Bunny Street

Developed design stage

Safe system audit

Report prepared for
Wellington City Council
September 2025

Figure 3-13: Proposed speed calming device will not slow vehicles exiting taxi loop prior to cycleway

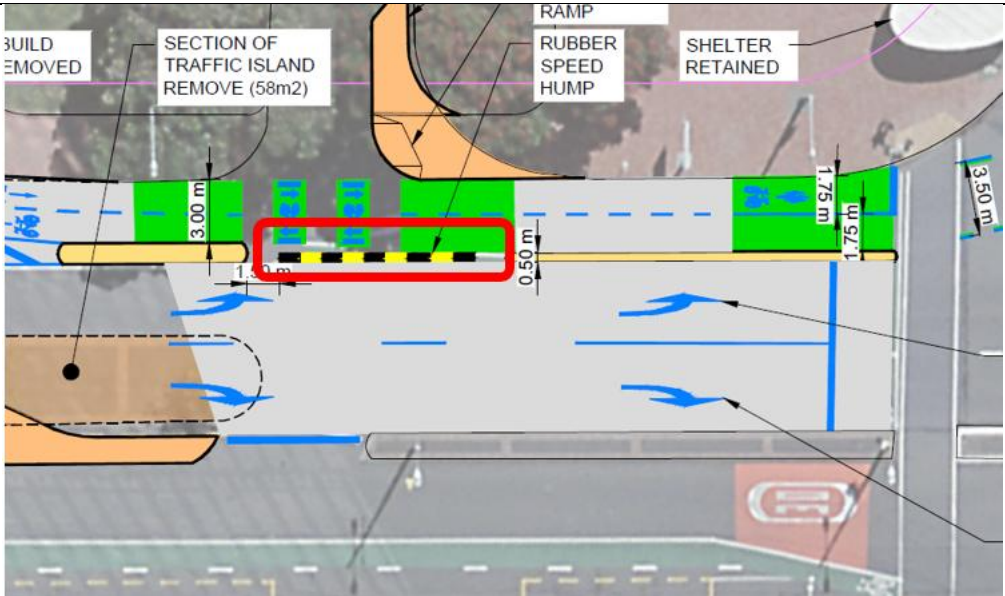
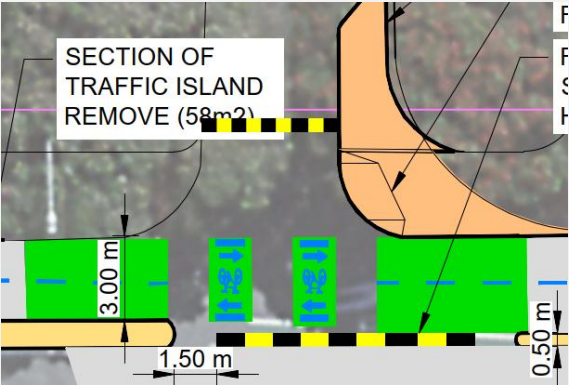
The safety issue is that drivers exiting the taxi loop will not be forced to slow their speed prior to crossing the cycleway. There is a speed calming device – the black and yellow speed hump circled in Figure 3-13 – however, this is on the departure side of the cycleway rather than the approach. The crash type expected is motor vehicle vs cyclist. The risk factors include: • Prevalence of taxi drivers in this location • Drivers potentially rushing to get a gap in traffic, or catch a green light at the nearby signalised intersection. • Two-way cycleway; drivers not expecting cyclists in the contra-flow direction. • Cycle volumes. The relevant guidance is the CNG technical note: High-use driveway treatment for cycle paths and shared paths, which shows speed calming devices on the approach to cycleways.	Probability of crash occurring	Unlikely
	Expected crash severity	Serious injury
	Primary treatment recommendations:

3.2.7.1	Locate a speed hump on the taxi loop approach to the cycleway.
	Supporting treatment recommendations:	
	3.2.7.2	In accordance with issue 3.2.6, retain the incorrectly positioned speed hump indicated in Figure 3-13, to help deter the wrong turn into the taxi exit.

Agree with recommendations. Additional hump prior to pedestrian crossing point as indicated below.

Client	Agree with responses.
Action	Addressed in final Developed Design by adding a raised platform at entrance and exit.

Figure 3-14: Bunny / Waterloo / Lady Elizabeth proposed phasing

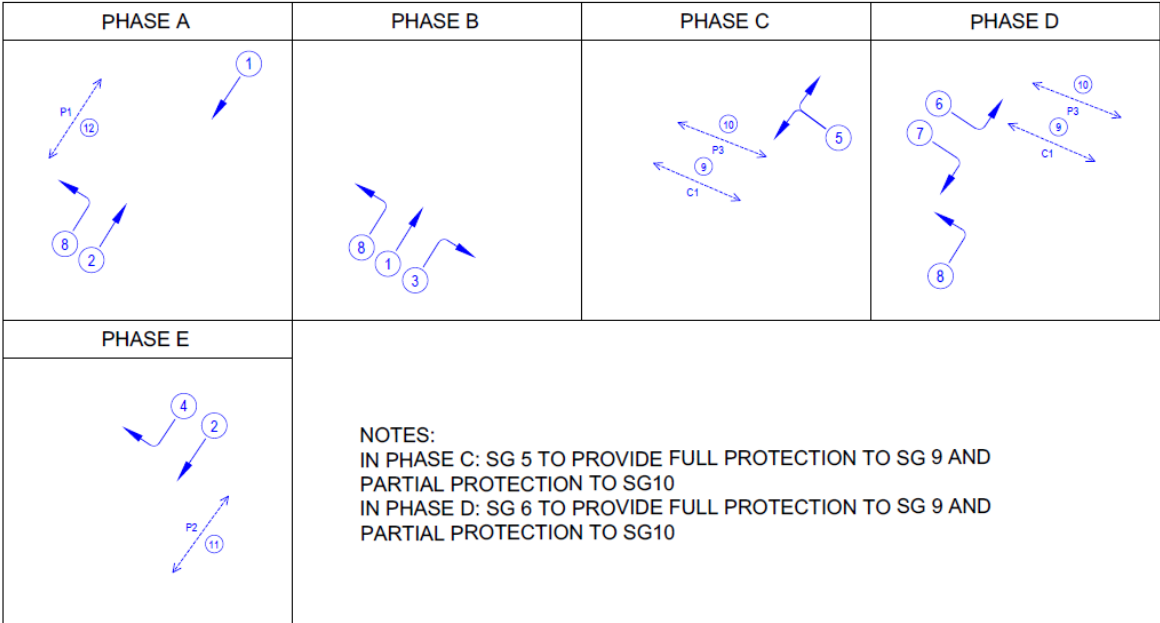
The Lady Elizabeth Lane approach to the Bunny / Waterloo intersection has been reduced from two lanes to one lane. Furthermore, the SSAT has been informed that the pedestrian crosswalk across	Probability of crash occurring	N/A
	Expected crash severity	N/A
	Primary treatment recommendations:

Waterloo Quay does not currently run in this phase, but the proposal adds the pedestrian crosswalk (with partial protection) and the cycle crossing (with full protection) to the C phase (see Figure 3-14). The SSAT understands that Lady Elizabeth Lane experiences brief but heavy traffic peaks when a ferry unloads vehicles. The reduction from two to one lane and introduction of pedestrian and cycle crossing movements in the C phase will exacerbate the situation. This will likely result in long queues and / or substantial extensions to the C phase (depending on how exactly the intersection phasing split is operated). The extent of this cannot be confirmed without intersection modelling.	3.3.1.1	N/A
	Supporting treatment recommendations:

3.3.1.2	Undertake intersection modelling to determine the likely queue lengths and level of service to motor vehicles on Lady Elizabeth Lane, and confirm whether this aligns with WCC's intended provision.
While a reduction in efficiency can lead to safety issues, the SSAT does not anticipate this at this location. There are several protective factors: • Full protection provided to the cycle crossing • Partial protection provided to the pedestrian crossing • Full and partial protection will be provided to the whole approach i.e. to both left turners and right turners (while right turns don't have any potential for conflict in C phase, if only a left-turn arrow were applied, they would likely get frustrated and try to bypass waiting left turners, or toot and encourage left turners to infringe the red light). • A tight radius that will control the speed at which left turners can turn towards the crossing • Drivers on the Lady Elizabeth Lane approach will have good visibility to any crossing users • Splitter island channelling the approach and preventing drivers from encroaching onto the departure lane. The SSAT supports the measures undertaken to gain more space on the corner for pedestrians and cyclists, given the numerous potential conflict points among the various different trajectories.

Responses:		
Designer	Concerns noted. Pedestrian and cycle phase to be removed from phase C.	
Safety Engineer	Recommend P3 stay on C phase. Most of the time the pedestrian walk runs in D phase which comes before C phase, then doesn't need to additionally run in C. Can leave C phase if the sequence remains the same and it is unlikely to cause an issue.	
Client	Agree with responses.	
Action	To be referred to designer and addressed in Detailed Design

Figure 3-15: No protection to SG 12

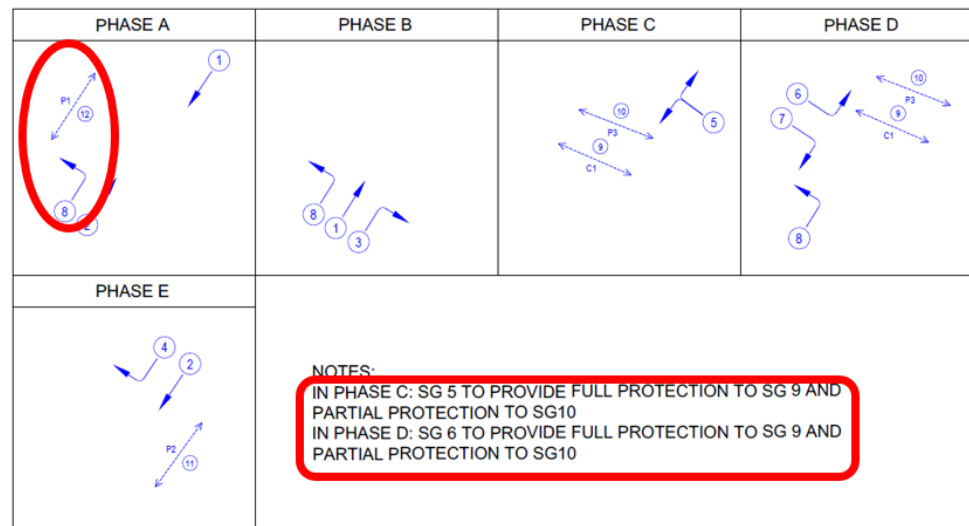
The safety issue is that the plans do not indicate that partial protection will be provided for the P1 movement, i.e. pedestrians crossing Bunny Street at the signalised intersection (SG 12).

- High pedestrian volumes
- Inconsistency with other crosswalks at this intersection and other intersections throughout the city, where pedestrian protection is the norm
- Intersection geometry allows for a reasonably fast left turn in this location

Provide partial pedestrian protection for pedestrians crossing Bunny Street (SG 12 / P1) by applying a red left-turn arrow to SG 8.

Agree with recommendations (as per existing operation).

Safety Engineer	Recommend partial ped protection for both SG9 and SG10. Don't need full protection as left turners in D phase would get ~5 seconds of green time. Agree with partial ped protection for SG8 (as per existing operation).
Client	Agree with responses.
Action	Refer to designer and address in Detailed Designs.

Figure 3-16: Diverging crossings from Lady Elizabeth Lane side

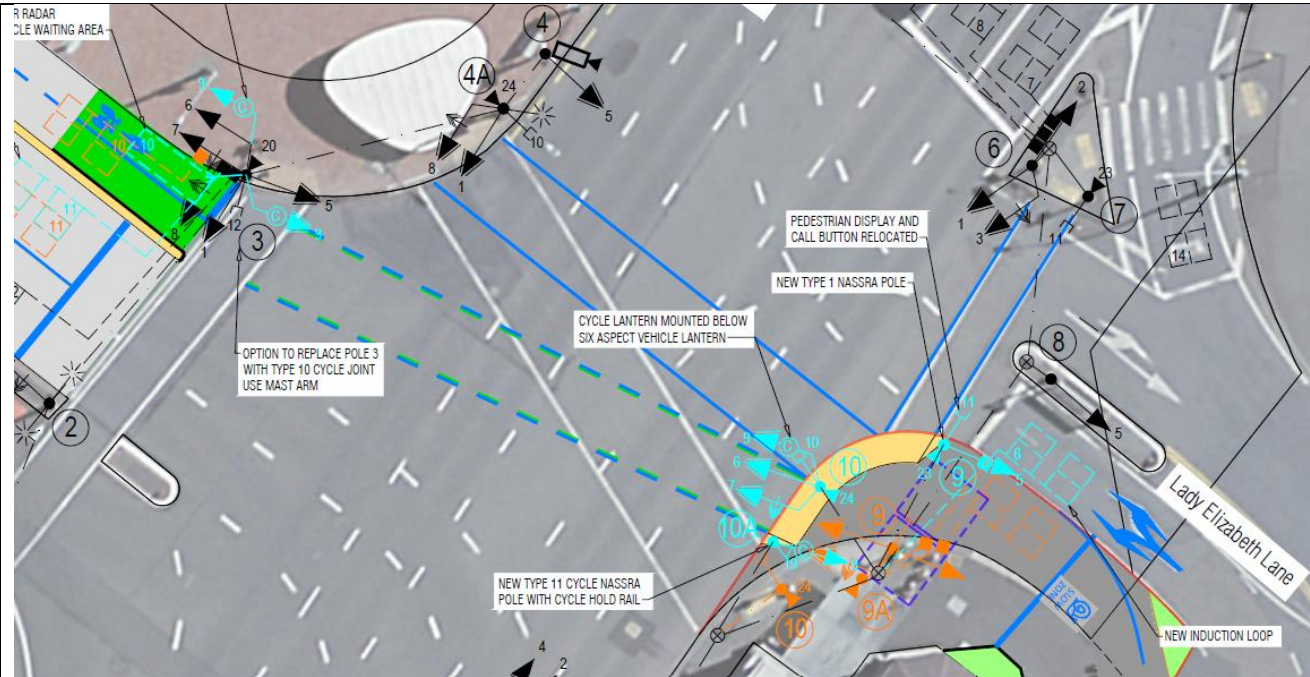
The safety issue is that pedestrians or cyclists could mistakenly start crossing at the crossing point intended for the other user group on the Lady Elizabeth Lane side of Waterloo Road, and end up in the wrong facility on the Bunny Street side. I.e. cyclists could end up on the footpath and pedestrians could end up on the cycleway. While there appears to be some green dashed lines marked for the cycle crossing, this may not be apparent to everyone (e.g. at night-time). The crash type expected is cyclist vs pedestrian. The risk factors include: • Pedestrians and cyclists changing from a shared space to segregated facilities. • The offset between the cycleway and the footpath on the Bunny Street side. • Familiarity with other locations where crossings remain side-by-side and users tend to just queue / cross wherever there is space available. The mitigating factors include: • Good visibility to the other side of the road, where the difference in the cycleway and footpath should be obvious and distinguishable. • Opportunity to change trajectory within the intersection, even if starting from the wrong location. • Temporal separation from motor vehicles.	Probability of crash occurring	Unlikely

Expected crash severity	Minor injury
	Primary treatment recommendations:	
	3.3.3.1	N/A
	Supporting treatment recommendations:	
	3.3.3.2	Mark the cycle crossing waiting area with green paint/tactiles and cycle symbols.

3.3.3.3	Mark the pedestrian crossing waiting area with yellow tactiles and pedestrian symbols.

Responses:	
Designer	Agree with recommendations.
Safety Engineer	Agree with Designer response.
Client	Agree with responses.
Action	Addressed in final Developed Designs.
